UCL Bicentennial Projects : Main Quad and Wilkins Cloisters

Addendum to Lighting Assessment for Planning and Listed Building Consent Submission

Revision: 00
Date: February 2025

Sketch showing re-located columns and spotlights.

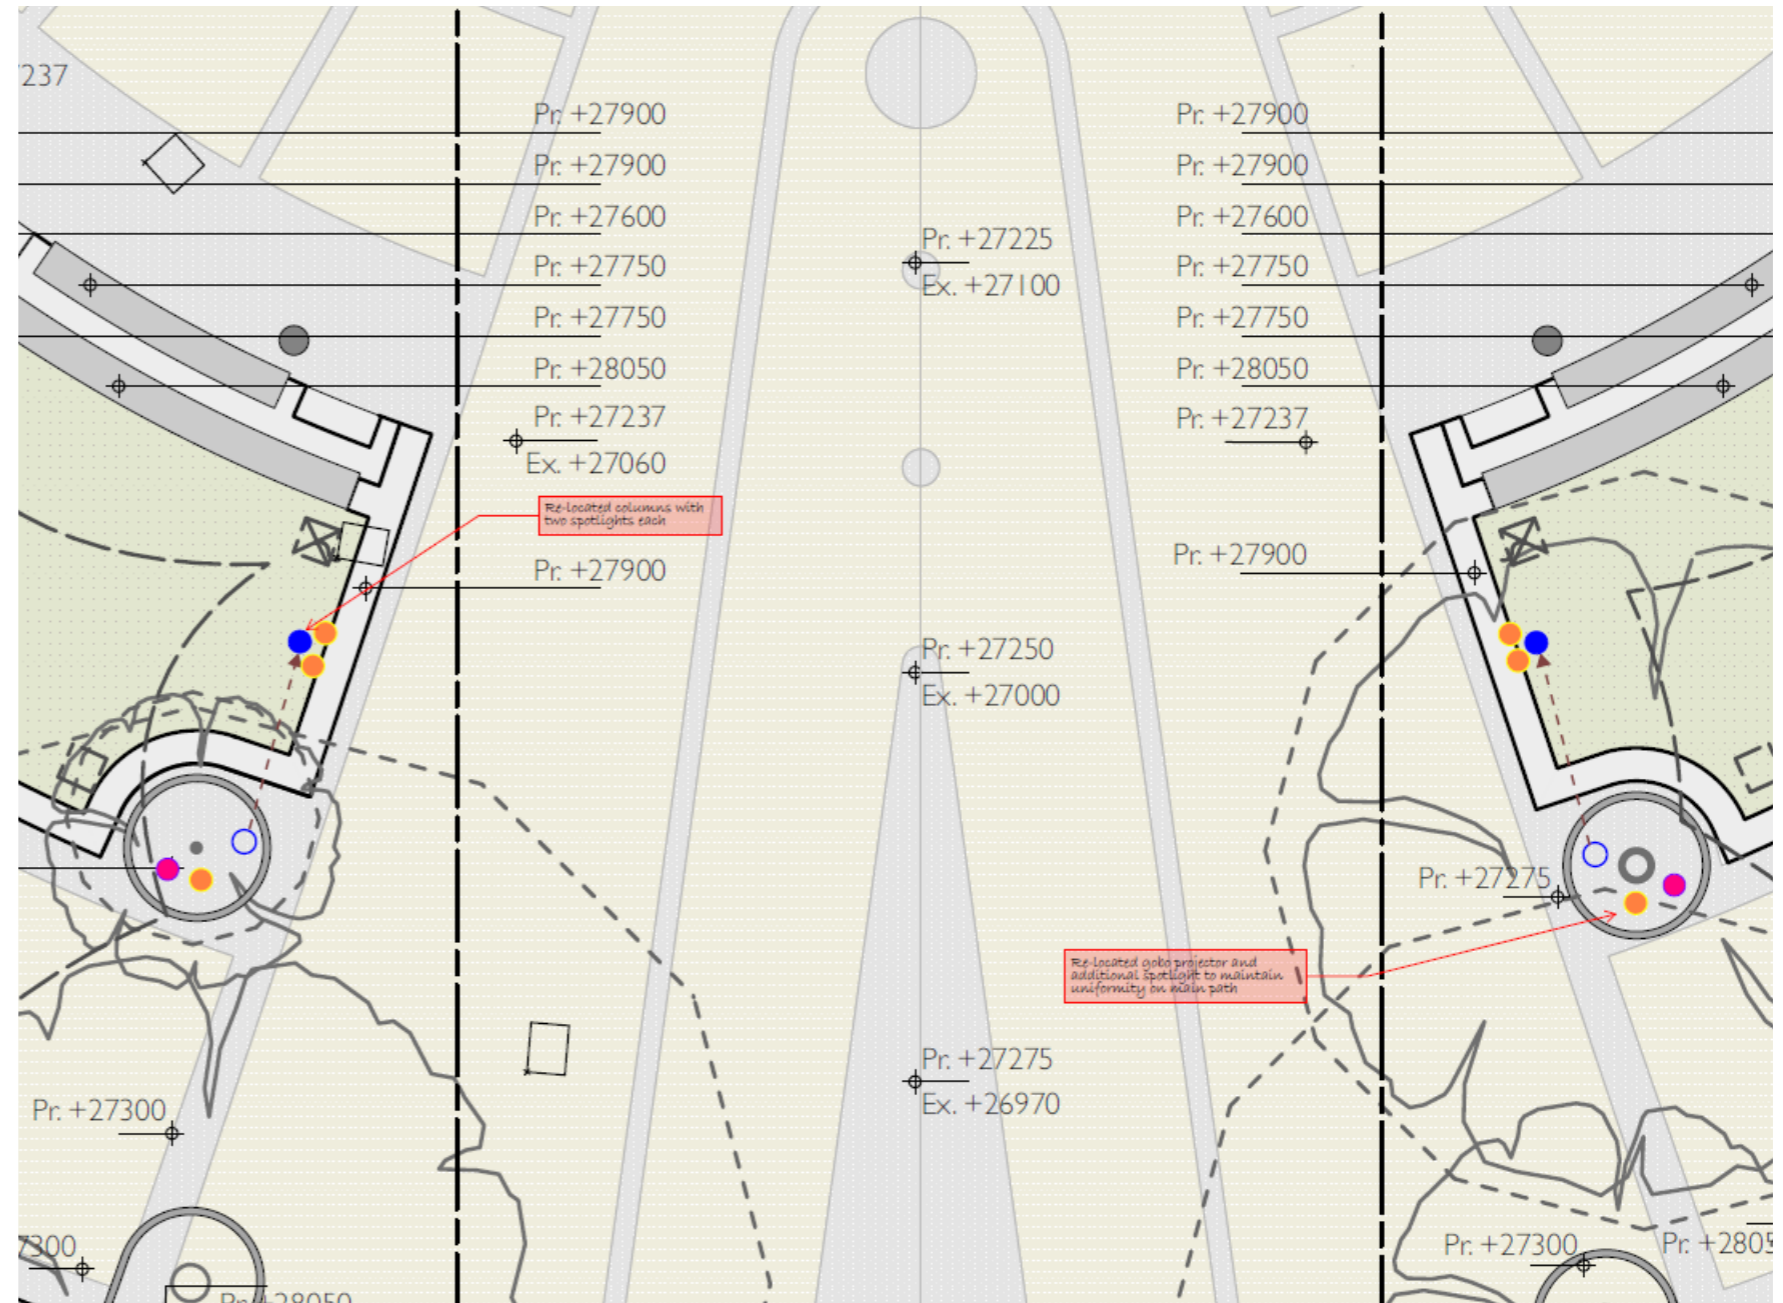
The purpose of this addendum is to showcase the impact on the proposed lighting design for the UCL Main Quad by the revised strategy of retaining four of the existing trees.

The retention of the trees has meant that two proposed lighting columns (3.0m high) have had to be re-located away from the trees. The columns have been moved to align with the centre of the proposed planters. Two of the spotlights have moved to the new column positions. The gobo projectors that were mounted on the columns will be moved to the trees and one additional spotlights will be added to those positions as well. This will ensure that the uniformity of the curved path lighting is maintained, along with the feature effect of the gobo projectors.

The lighting calculations have been updated in line with these changes. The column move has necessitated the addition of two spotlights of the same size, appearance and optics to maintain light levels and good uniformity to the curved path. The re-location of the columns has improved the light levels on the main path leading to the centre of the Quad.

Image showing calculated illumination presented in false colours

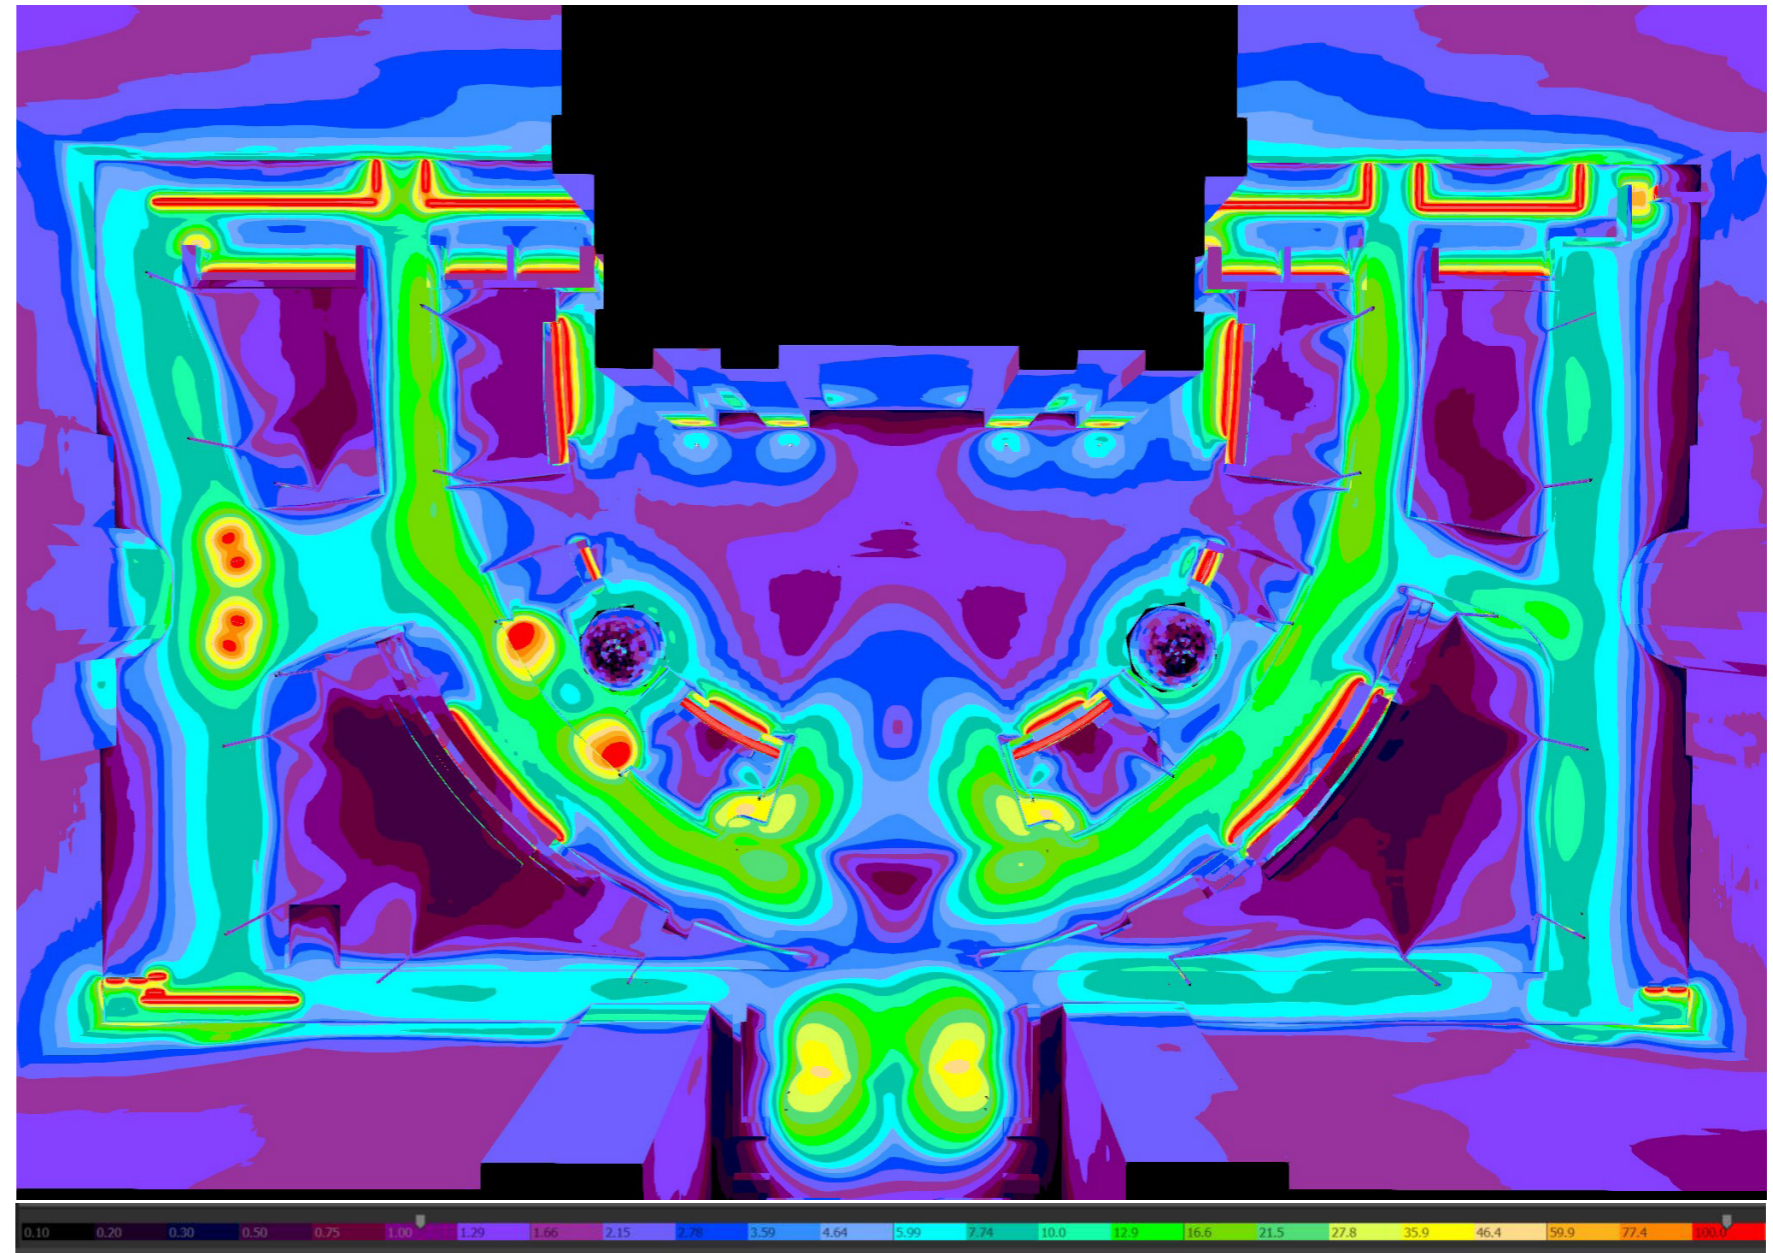
The emergency escape lighting has not been adversely affected by the column move. The spill light calculations (detailed on the next page) have not been adversely affected by the column move.

The calculation results, illustrated here with false colours, demonstrate our strategy to provide lighting where it is needed. This is achieved using high-quality lighting equipment with precise optics. Main circulation areas and entrances are illuminated the most, while greenery and natural areas are left unlit to preserve their natural cycles. The calculated illumination levels on the building facades indicate minimal light spill into the interiors, maintaining levels well below ILP Guidance which states maximum value of vertical illuminance on properties post-curfew at 5 lux.

Facade N - Light trespass	
▶	3.59 lx 0.38
Facade S - Light trespass	
▶	4.08 lx 0.38
▶	3.18 lx 0.40
Facade W - Light trespass	
▶	2.37 lx 0.56
▶	2.63 lx 0.55
